Planning Approval Consistency Assessment Form

| Assessment Name: | St Marys Station Platform 3/4 Canopy Removal |
| Assessment number: | LOR 001 |
| Planning approval No. (where relevant): | SSI 100511 EPBC 2020/8687 |

Figure 1 Location of proposal at St Mary's Station (canopy to be removed shown in red for clarity).

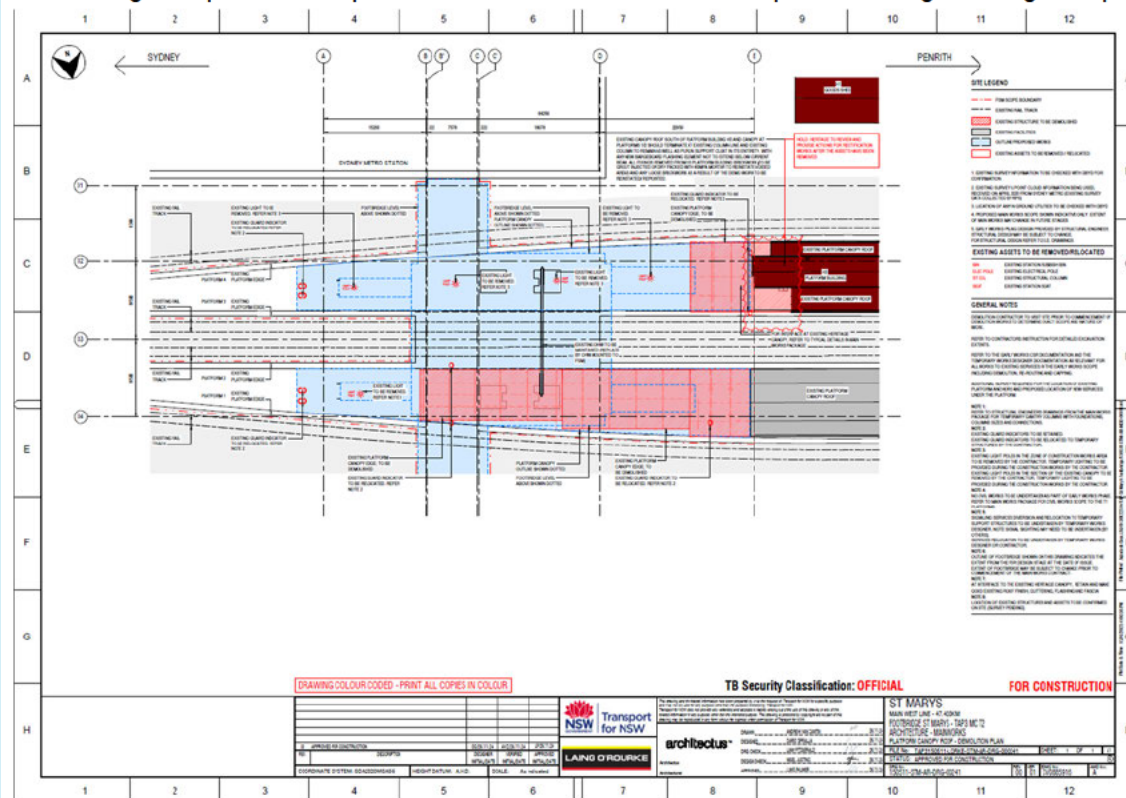
The existing FSM platform canopies were documented to be removed up to the heritage building as depicted by the red dashed area:

Figure 3: Changes proposed to the Platform 3/4 Canopy at St Marys Station (additional section to be removed highlighted in blue).

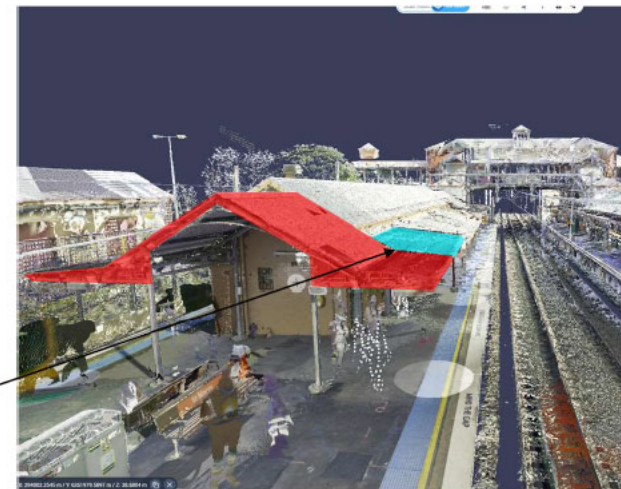
Additional section
removed and not
replaced

Additional section removed
which removes the
obstruction to original
awning structure

Details of the heritage impact of the Platform 3/4 canopy can be found in section 6.2 of the Heritage Impact Assessment (Appendix A) and confirms that “the proposed removal of the 1990s awning from the eastern portion of the 1888 station building on Platform 3/4 would provide a positive heritage outcome.”
